City of Pensacola

Planning Board

Agenda

December 12, 2023, 2:00 PM

SITE PLAN
ROOF PLAN

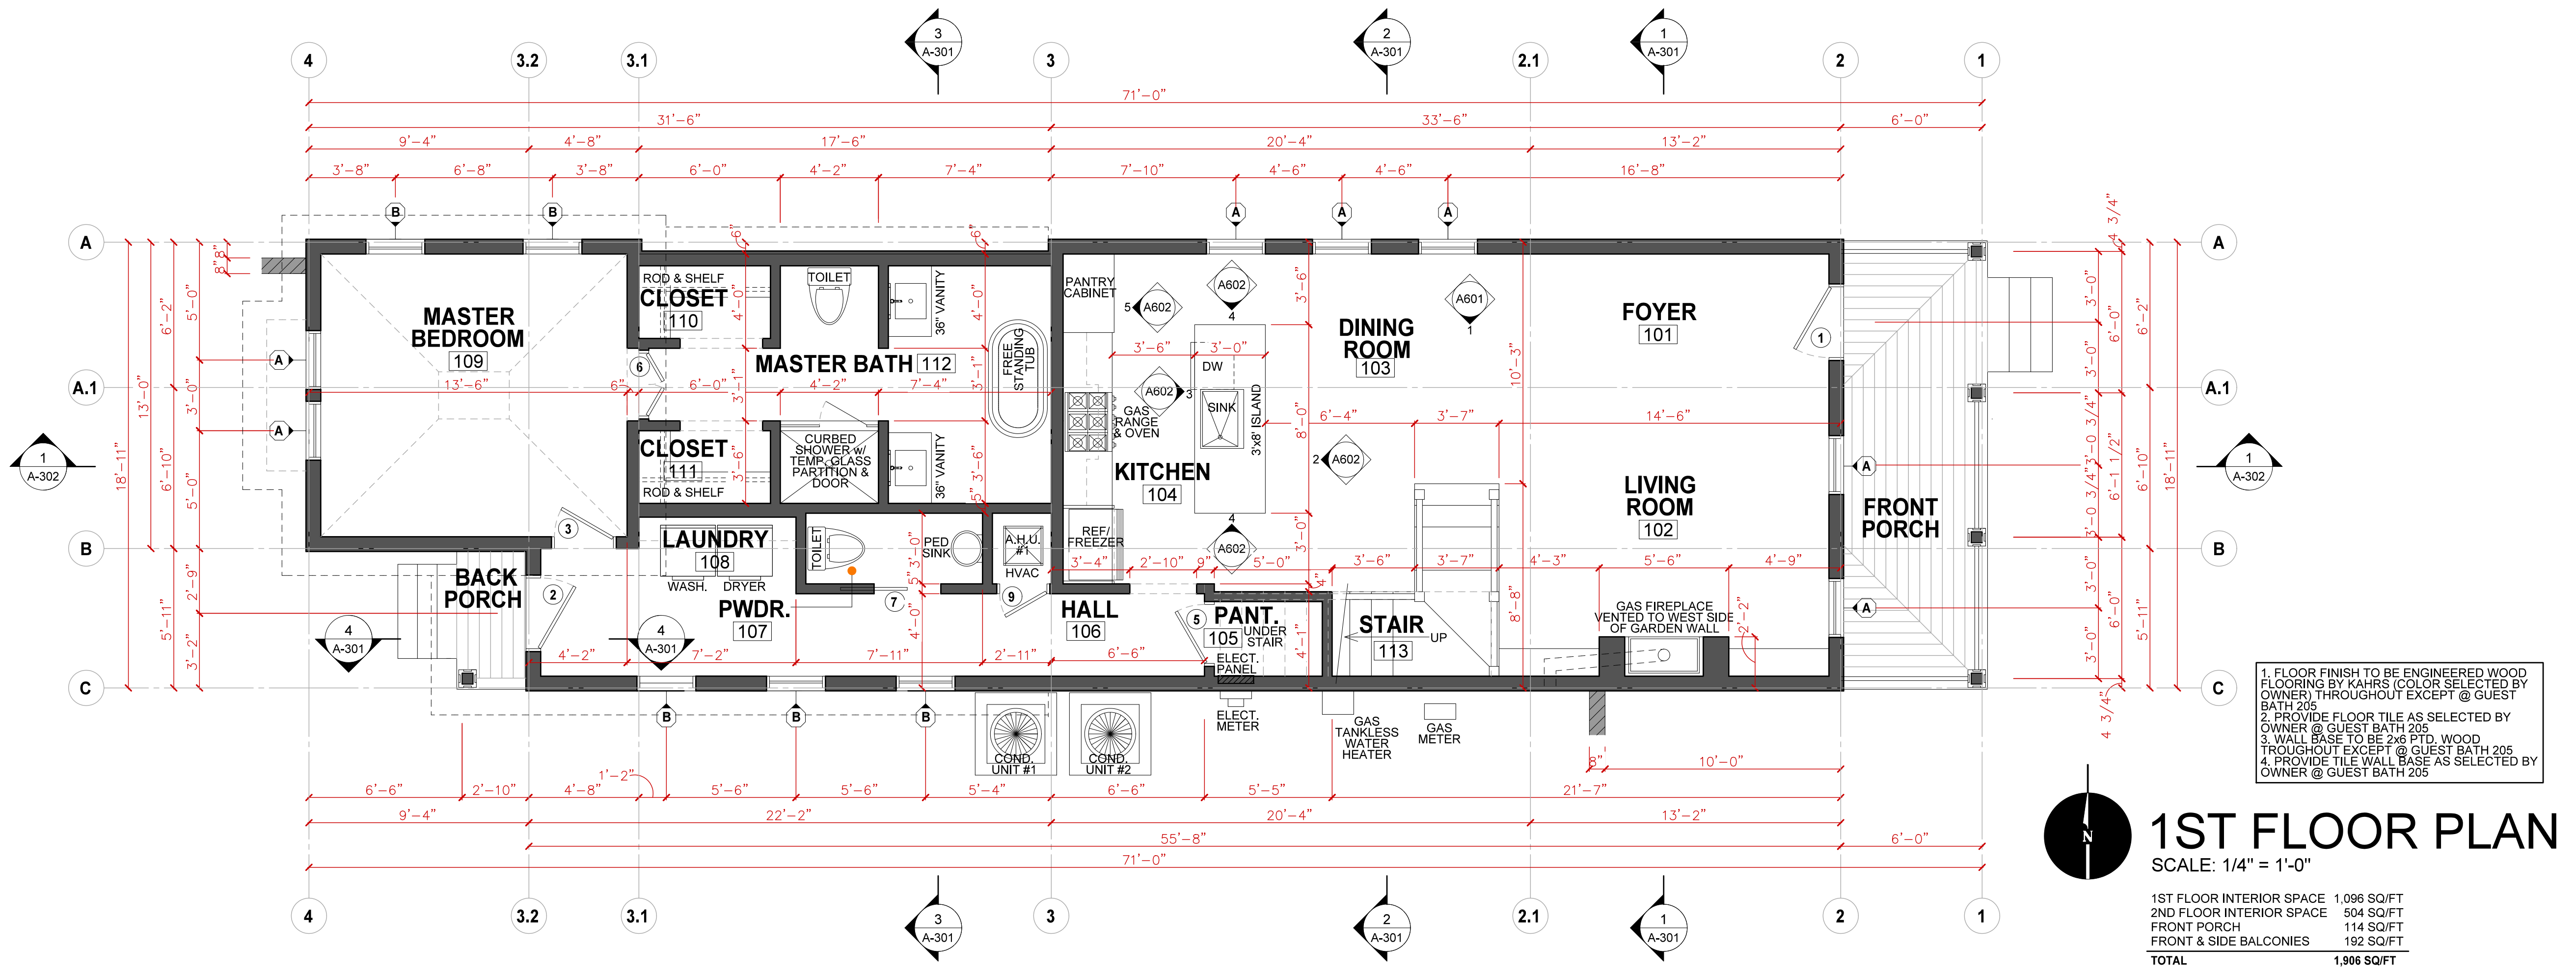
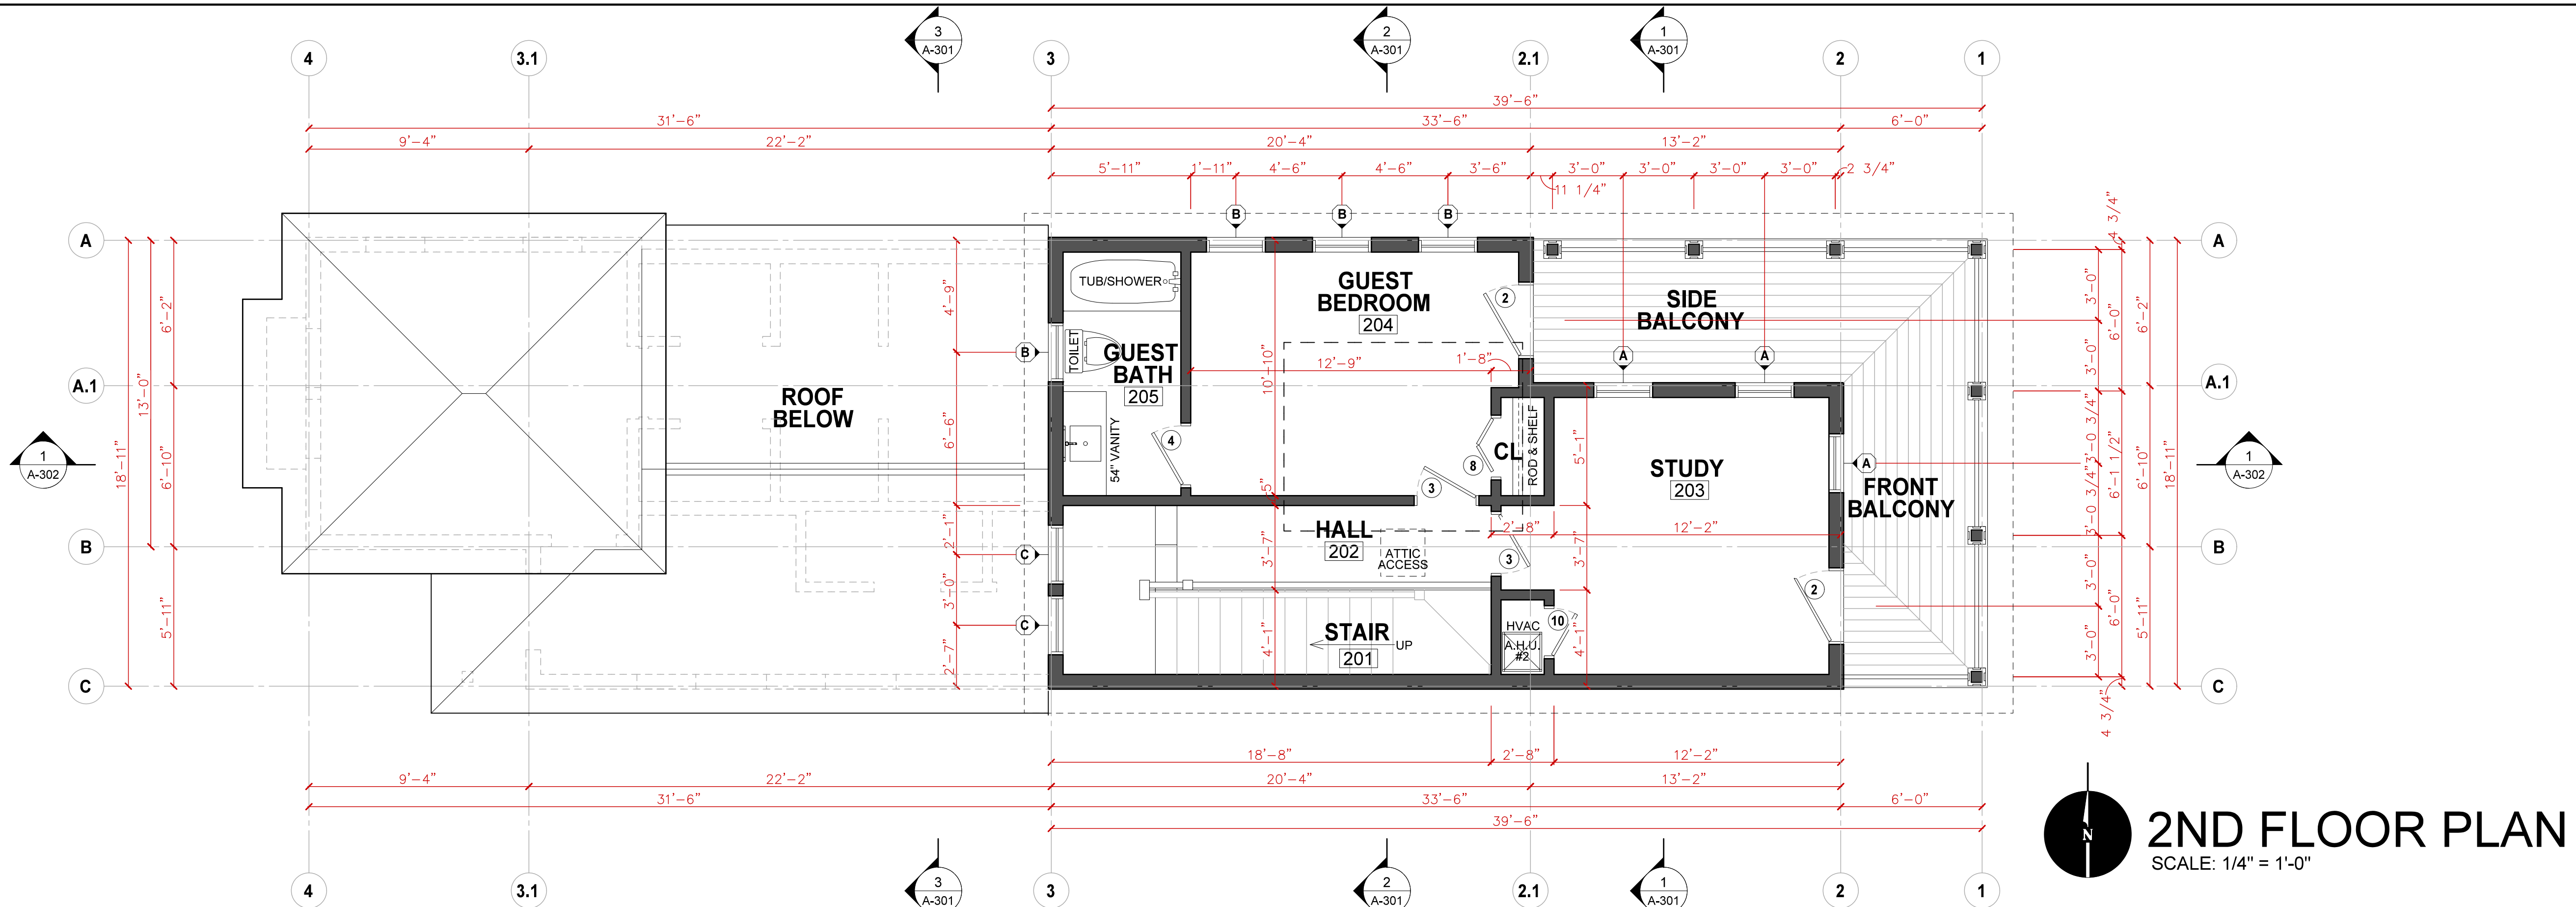
2. Please submit an elevation for the car gate. Note the trash can storage location should not be visible from the street. **A car gate elevation has been added. See 7/A403 attached. A screen fence to obscure the view of the trash can has been added. See 8/A403 and Site Plan attached.**

4. Please include product information of permeable paver including percentage of permeability. **Since our previous submission the homeowner provided alternate instructions regarding the pavers. The courtyard now feature 24x24 porcelain pavers with dwarf mondo grass in between. Additionally the parking pad has been changed to a ribbon driveway. These changes are reflected in the updated lot area calculations. See attached site plan and supporting photos of the paver and example of mondo grass between the pavers.**

5. Please clarify that there is no sod, only planted areas with pine mulch. **There is no sod other than the dwarf mondo grass between the porcelain pavers.**
